Item ID: D3016-17 Accept ***N900040100*** Setup Start ***NS1***
 Revision ID: Stop ***NS2***
 Item Name: Gusset
 Start Date: 10/30/12 Start Qty: 6.00 ***6*** Cust Item ID:
 Required Date: 11/16/12 Req'd Qty: 6.00 ***6*** Customer:
 Reference:

D3016-041 SEAT FRAME ASSEMBLY

DRAWING NO. D3016	TITLE SEAT FRAME ASSEMBLY	REV. A	DART AEROSPACE LTD ENGINEERING ORDER	D.E.O. NO. D3016-A-1	SHEET NO. SHEET 1 OF 1	SCALE NTS
DRAWN 1	CHECKED UP	MFG. APPR. R	APPROVED W	DE APPR. H		
DATE 10.01.29	DATE 10.01.29	DATE 10.01.29	DATE 10.01.29	DATE 10.01.29	DATE 10.01.29

D3016-11 SADDLE

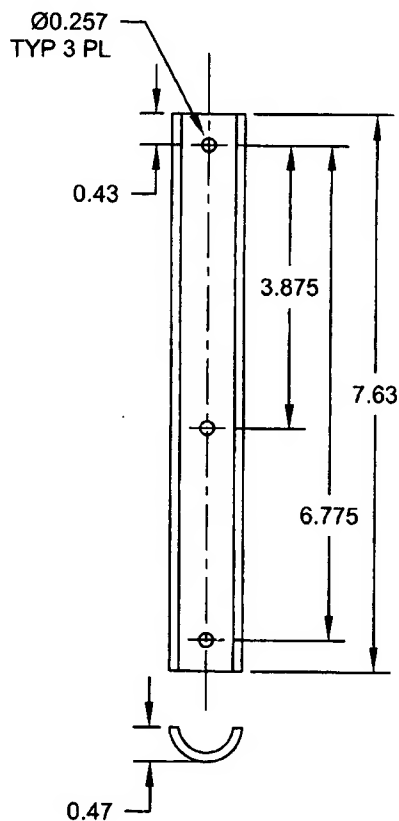
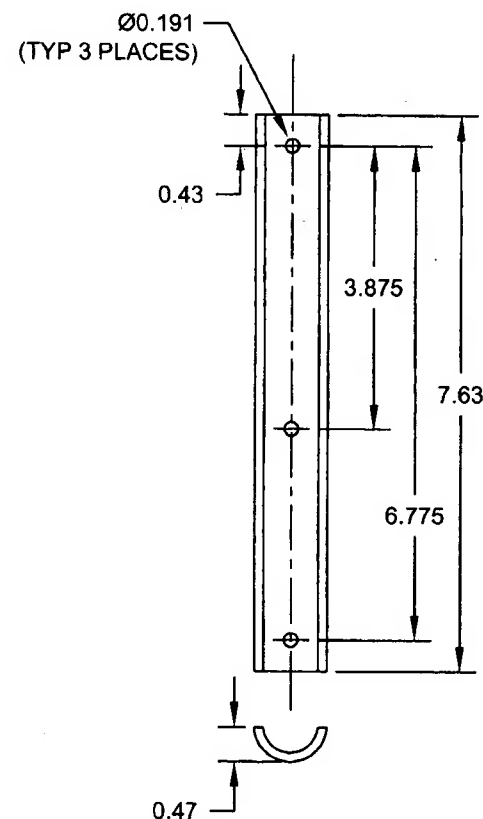
TO REVISE D3016-11 SADDLE'S HOLE SIZES

DETAIL D3016-11 SADDLE (SHEET 3): Ø0.257 TYP 3 PL WAS Ø0.191 (TYP 3 PLACES) AS SHOWN:
